INDEPENDENT PEER REVIEW OF SANCROX QUARRY EXPANSION GROUNDWATER MODEL

GW-HANSON-20-02-REP-001

SANCROX QUARRY EXPANSION

Figure 2-1 Groundwater monitoring bores

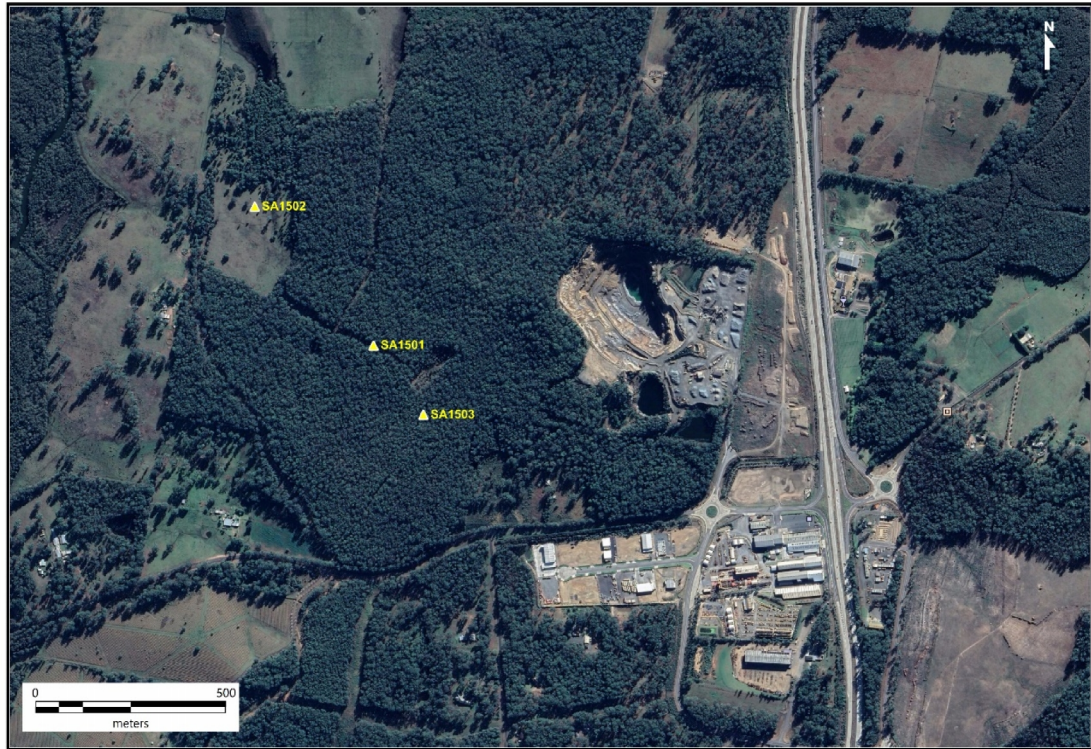
These bores are located in a near straight line which is not ideal for inferring groundwater flow directions spatially within the study area. Historical water levels that were collected from these bores were neither provided nor analysed to understand the hydrological stresses. It is also noted that no hydrogeological information from the surrounding groundwater bores, GW060512, GW060513, GW300120, GW301263, GW302376, GW303436, GW303749 and GW306269, has been included in the groundwater model development.

Figure 2-4 Plot of residual and monthly rainfall

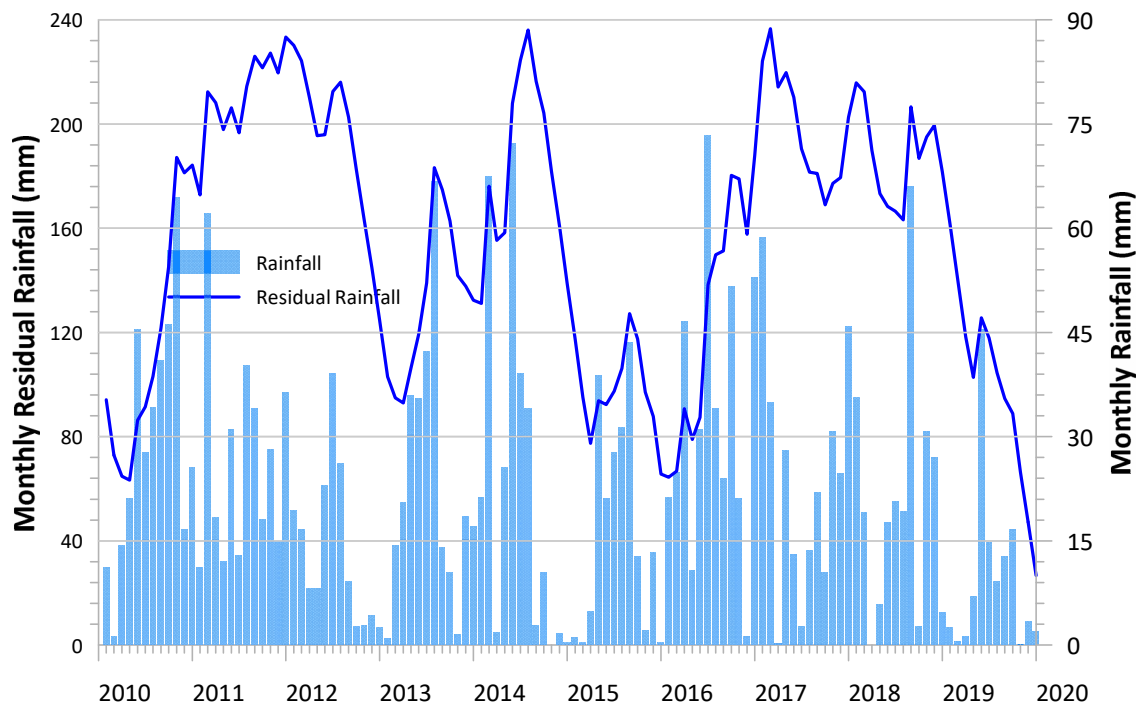
No verification of the model performance was reported. Verification is a test of whether the model can be used as a predictive tool by demonstrating that the calibrated model is an adequate representation of the physical system. The steady state model has been calibrated based on the groundwater elevation data collected on 28 November 2017 and the rainfall data available for the site from the DataDrill⁵ climate repository (**Figure 2-4**) indicates that the Study Area experienced more than average rainfall in the latter part of 2017.

Consideration should be given to verification of the model using the logger data to assess if the model is a reliable tool for the prediction of groundwater level fluctuation with varying climate data.
